THOMAS GERLACH and DIRK DRÖGE  
U.S. Patent Application S.N. 10/717,543

**IN THE DRAWING:**

Please amend FIG. 2 as follows:

Fig. 2

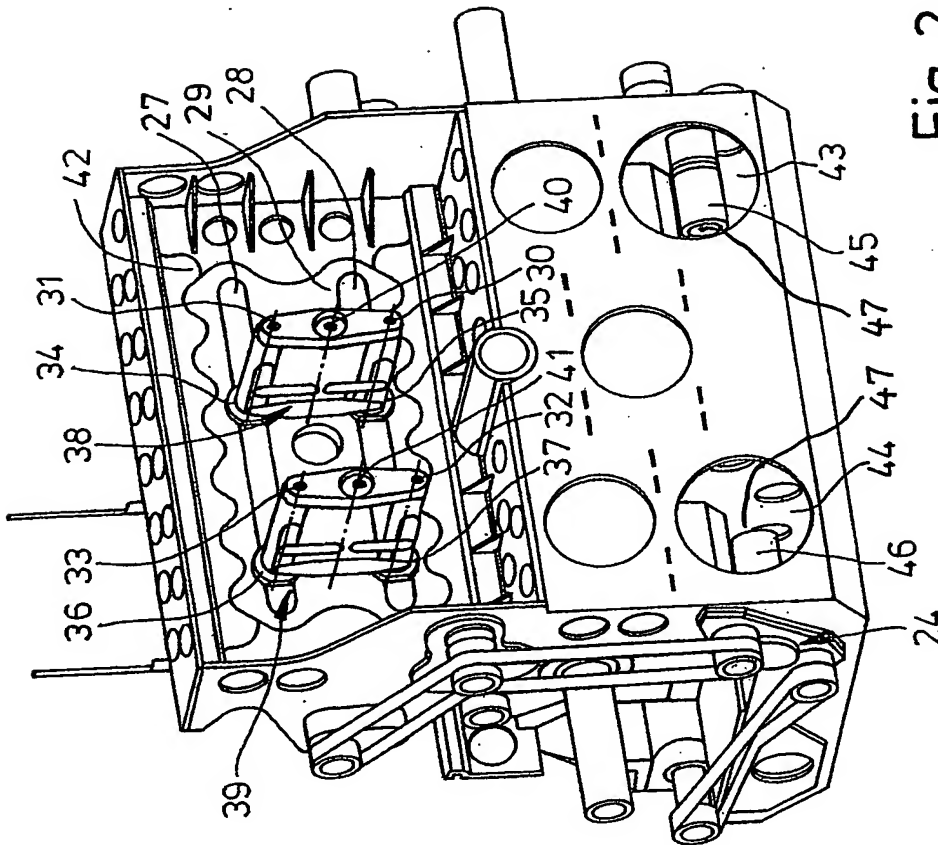
1. Please add a reference line and reference number 47 to illustrate the position sensor on drive motor 45 as indicated in red in the attached "ANNOTATED MARKED-UP DRAWINGS" of FIG. 2.

2. Please add a reference line and reference number 47 to illustrate the position sensor on drive motor 46 as indicated in red in the attached "ANNOTATED MARKED-UP DRAWINGS" of FIG. 2.

After the telephone interviews the undersigned attorney reviewed the Specification and discovered the drawing, namely FIG. 2 did not show a position sensor even though paragraph 25 and claim 10 of the Specification as originally filed claimed and described the position sensor.

Under 37 CFR § 1.83 and MPEP § 608.02(d) the drawing must show every feature specified in the claims. The original drawings, Specification and claims show the features but the claimed position sensor is not referenced in the drawing (FIG. 2). As a result FIG. 2 should be amended as well as Paragraph 0054 of the Specification to incorporate reference lines and reference numbers 47.
